SUBJECT: REPORT FROM AD HOC PANEL ON POTENTIAL RED OIL EVENTS
AT THE PROPOSED MIXED OXIDE FUEL FABRICATION FACILITY,
DPO-2005-002

REPORT OF THE AD HOC PANEL
CONVENED BY THE NMSS DIRECTOR TO REVIEW THE DIFFERING PROFESSIONAL
OPINION PERTAINING TO RED OIL EVENTS AT THE PROPOSED MIXED OXIDE (MOX)
FUEL FABRICATION FACILITY (NMSS-DPO-2005-002)

DIFFERING PROFESSIONAL OPINION ON
RED OIL EVENTS AT THE
PROPOSED MIXED OXIDE (MOX) FUEL FABRICATION FACILITY
DOCKET NUMBER: 070-03098

Figure A: Comparison of the Applicant's Red Oil Safety Strategies with DOE/DNFSB (formerly Open Item CS-01) Recommendations

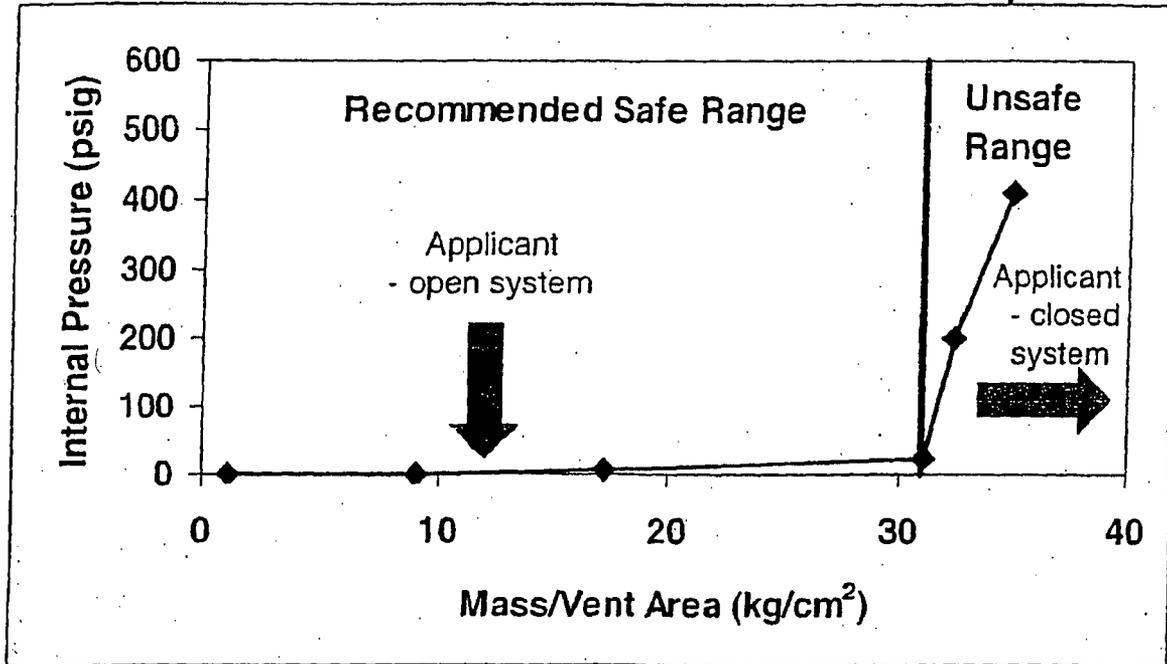
1. Contradictions with DOE/DNFSB RAGAGEP (Reasonable And Generally Accepted Good Engineering Practice) are not explained. In particular, the RAGAGEP shows the applicant's proposal for closed systems being entirely in the unsafe regime (Figure 2).
2. There is inadequate margin in the design basis temperature.
3. The venting is insufficient to avoid choked flow and pressurization, which has the ability to rapidly raise the temperature even with the applicant's proposed strategy functioning.

Figure 2: Comparison of the Applicant's Red Oil Safety Strategies with DOE/DNFSB (formerly Open Item CS-01) Recommendations

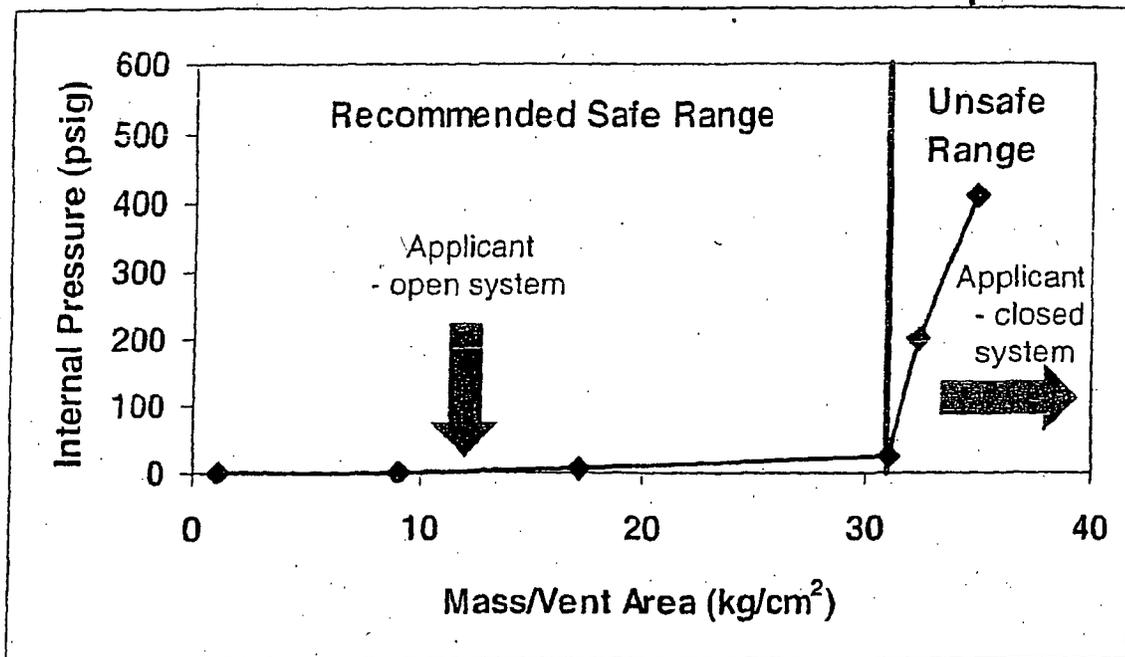
Pressure/Venting: DOE/DNFSB use a pressure/vent relationship (Figure 2) that is well within the safe range identified from experimental testing. The applicant's approach for open systems is also well within the safe range. In contrast, the applicant's approach for closed systems (i.e., evaporative cooling) far exceeds the safe limit and is well into the unsafe range. Common mode failure is likely - reaction products from the red oil reactions cannot escape and provide evaporative cooling, resulting in choked flow, which increases temperature, resulting in suppressed evaporation, which increases temperature, resulting in increased red oil reaction rates etc. - ultimately, this leads to a runaway reaction and explosion. The loss of evaporative cooling effectiveness above 120 C is noted in articles cited in the staff's DSER and RDSER.

1. Contradictions with DOE/DNFSB RAGAGEP are not explained. In particular, the RAGAGEP shows the applicant's proposal for closed systems being entirely in the unsafe regime (Figure 2).
2. There is inadequate margin in the design basis temperature.
3. The venting is insufficient to avoid choked flow and pressurization, which has the ability to rapidly raise the temperature even with the applicant's proposed strategy functioning.
